MEMO

Project:	ANCCG	Document No.:	Mm 019		
To:	Auckland International Airport Ltd	Date:	27 May 2024		
Attention:	Jeremy Lo	Cross Reference:	ANCCG Report 2023 Q4 Nov-Jan		
Delivery:	Email	Project No.:	2005528A		
From:	Stephanie King	No. Pages:	2	Attachments:	No
Subject:	ANCCG - Responses to 2023 Q3 queries

Figure 1: Auckland Airport runway splits since 2005

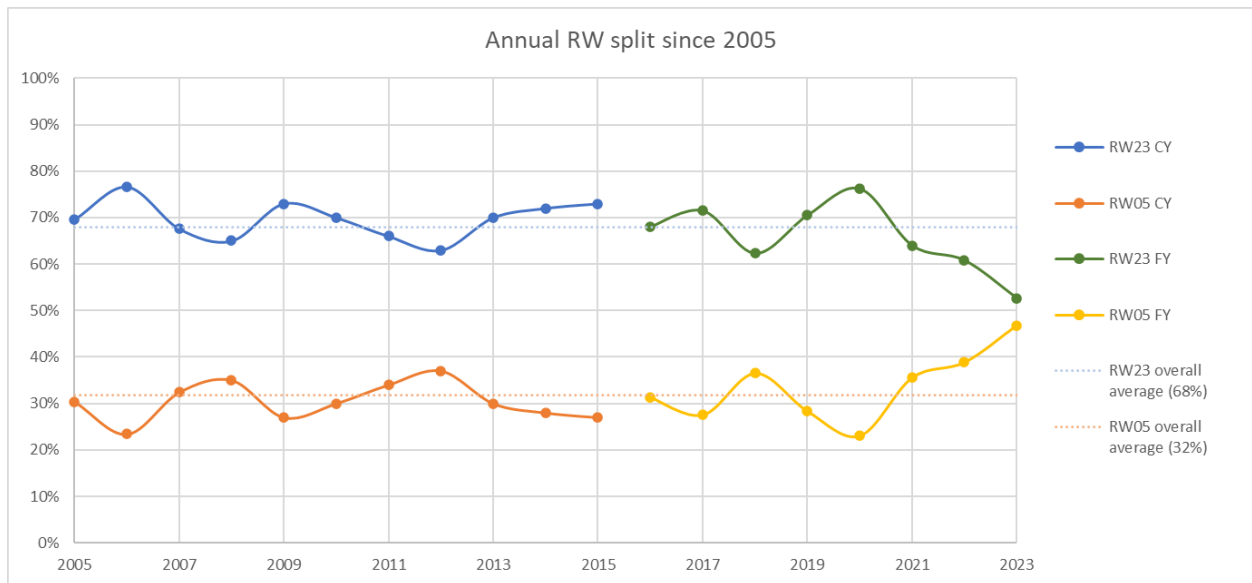
2. [Should we change the calculation methodology of the FY24 forecast contours? That is – should we calculate it using a typical RW split rather than the previous year's RW split \(in this case, using a 70/30 RW split rather than a 50/50 RW split\)](#)

- Only the FY23 had an especially abnormal RW bias (see figure overleaf)
- The current overall average is roughly a 70/30 split (68/32), and this abnormality issue has not happened in the last 20 years. But if the abnormal RW split persists (with changing weather patterns/climate change), we will look into adjusting the typical RW split.
- Overall, our view is that it is unnecessary to change the methodology as we are following the designation. The designation says to use the ANC to calculate the forecast AANC (i.e. use the FY23 Actual Noise Contour to calculate the FY24 forecast Annual Aircraft Noise Contour).
- Out of interest, I modelled the FY24 AANC using a 70/30 scenario and there is only a minor change that shows it is likely that the properties "missing out" will be included in the next year's AANC.
